USB Type-C ENGINEERING CHANGE NOTICE

Title: Correct mis-cropping of Figure A-2

Applied to: USB Type-C Specification Release 1.0, August 11, 2014

Figure A-2 Example 3.5 mm to USB Type-C Adapter Supporting 500 mA Charge-Through

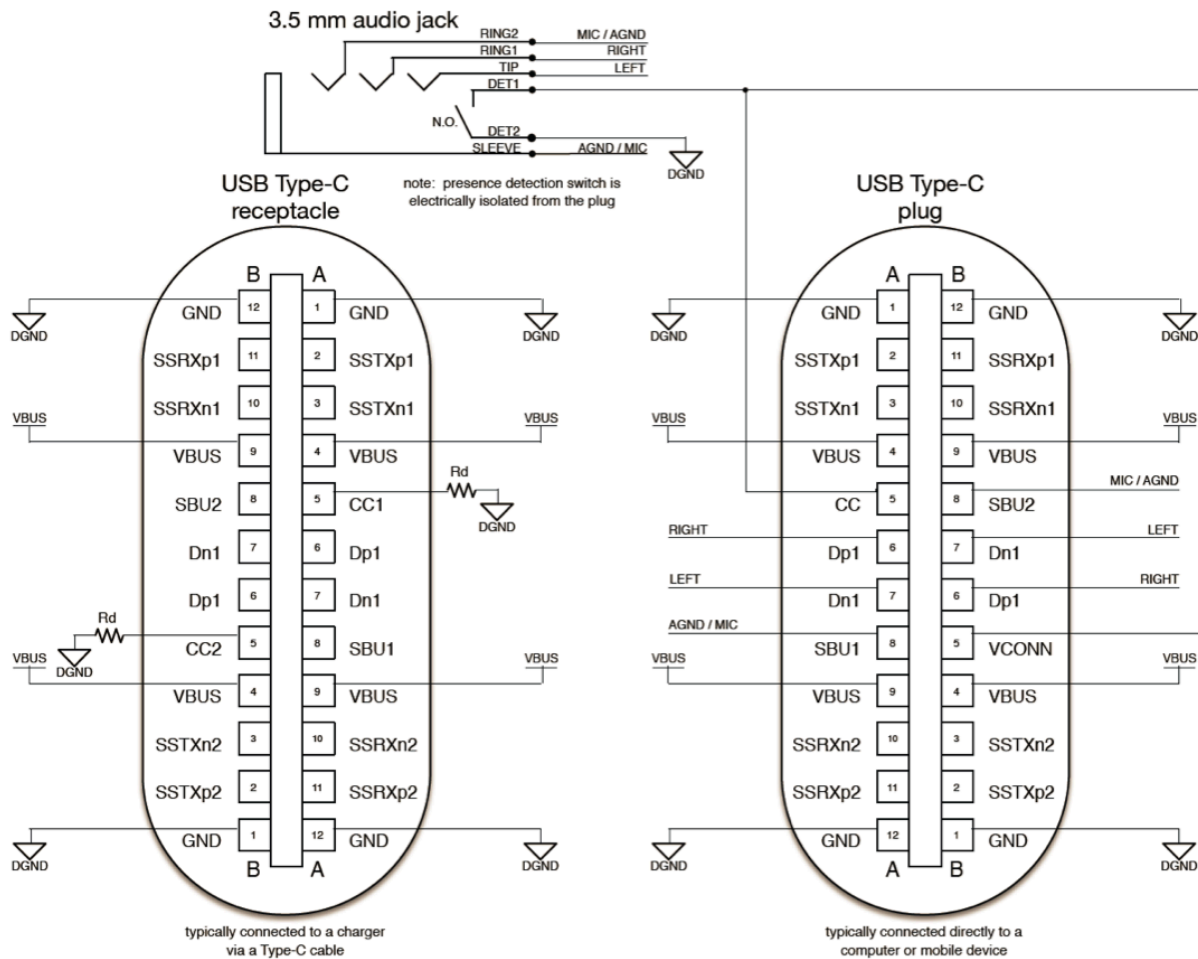
Correct the mis-cropping of Figure A-2. As published, the cropping removes the connection between VCONN and DET1.

(a). Section A.4.2, Figure A-2 (if applicable), Page 170

Correctly represent the figure, showing the connection between VCONN and DET1
